## Planning Commission Staff Report

February 13, 2013  
Item 5.a.

**SUBJECT:** P12-1716 / P13-0007

**PURPOSE:** Applications for Design Review approval to demolish the Santa Rita Junction Shopping Center buildings totaling approximately 11,591 square feet and construct an approximately 3,431-square-foot single-story financial institution building with a detached 24-hour one-lane drive-through; and for Sign Design Review approval for building- and ground-mounted signs for J.P. Morgan Chase located at 3506 and 3510 Old Santa Rita Road.

**FIGURE 5:** Proposed Site Plan

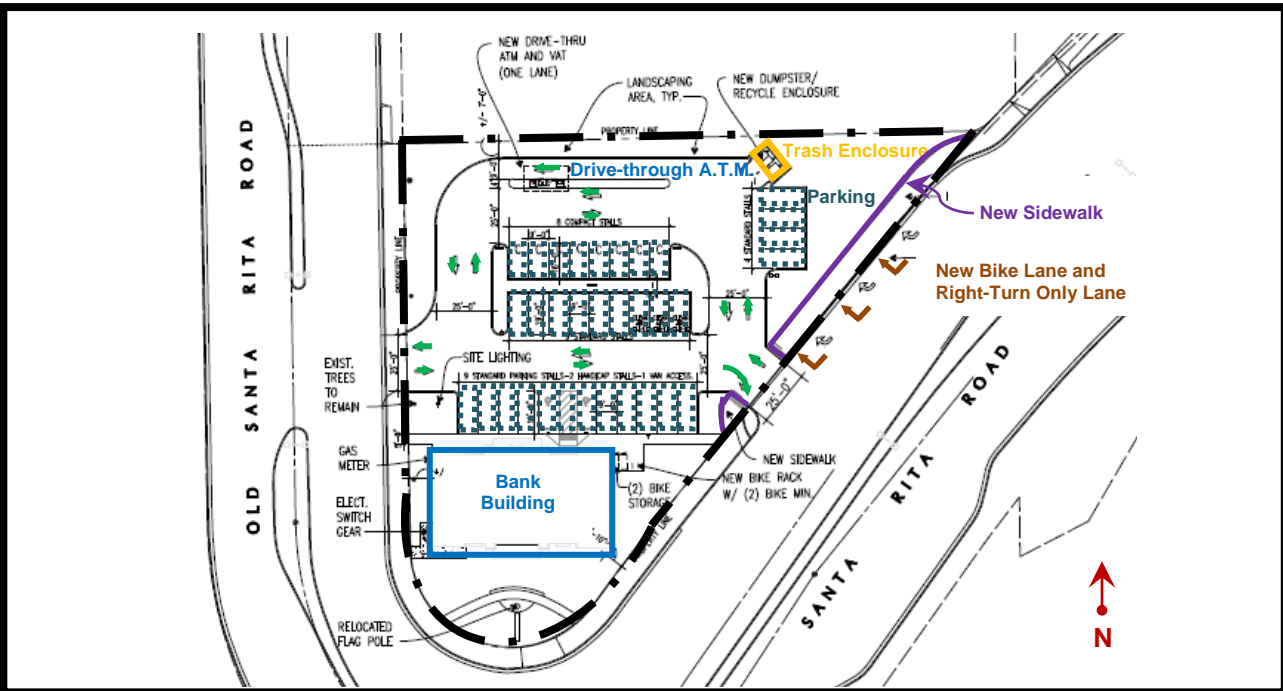
The existing driveways from Santa Rita and Old Santa Rita Roads will remain in their current location. As shown in Figure 5 and on project plans, a new right-hand turn lane will be added on south-bound Santa Rita Road. In order to accommodate the new right-turn lane from Santa Rita Road, the existing sidewalk will be removed and a new sidewalk will be constructed, offset to the west. In order to provide a contiguous pedestrian path, the sidewalk approach on the south side of the driveway will be modified such that its approach aligns with the approach of the new proposed sidewalk to the north of the driveway.
